12. Zoning By-law Amendment – 339-343 Gloucester Street

File Number: ACS2020-PIE-PS-0082

SUBJECT: Zoning By-law Amendment – 339-343 Gloucester Street

Document 4 - Proposed site plan

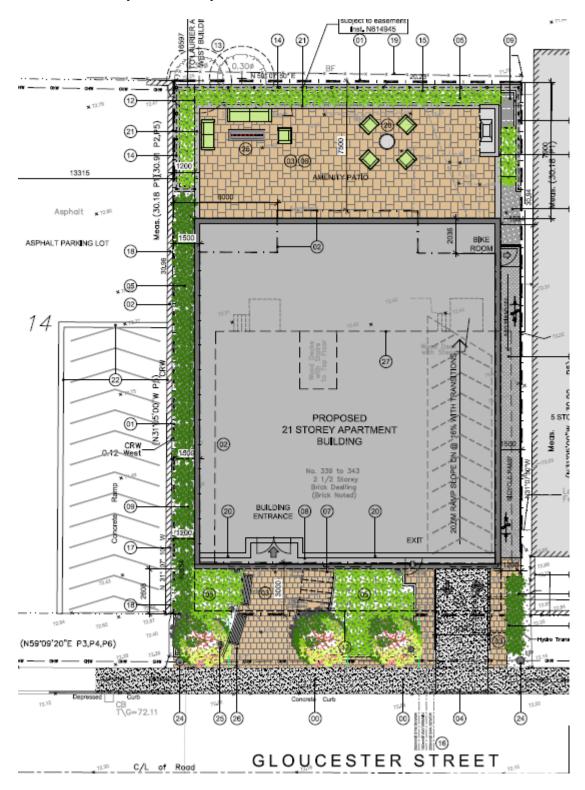
This project will affect view and shade and create intrusion of privacy issues for 470 Laurier.

This project will further congest traffic and parking. Gloucester and Bay are both one-way single-lane streets. This block already has several large apartments garage accesses. Moving trucks, delivery trucks, garbage collection and on street parking already congests this block immensely.

This proposed building would add garbage bins on the north side of the street, turning Gloucester into an obstacle course for cars, bicycles and pedestrians.

The proposed parking ratio is inadequate for the area where parking is already extremely limited.

• The single driveway does not provide sufficient space for opposing traffic. This imposes a safety risk to both motor vehicles and bicycle users.

The applicant agreed to reduce the building footprint in order to meet the required rear yard setback, which will help minimize the impact on adjacent properties.

This development is going to provide only 12 parking spaces and as such, will have a minimal vehicular impact on the surrounding streets. It encourages the use of alternative forms of transportation.

Issues related to garbage collection will be addressed through the Site Plan Control process.

This development, which is located in the Central Area, encourages the use of alternative forms of transportation and provides people who do not have or need the use of a private automobile the opportunity to live within an area where amenities are located within walking distance.

With only 12 parking spaces to be provided on site, the relief sought is not expected to result in on site vehicle conflicts.
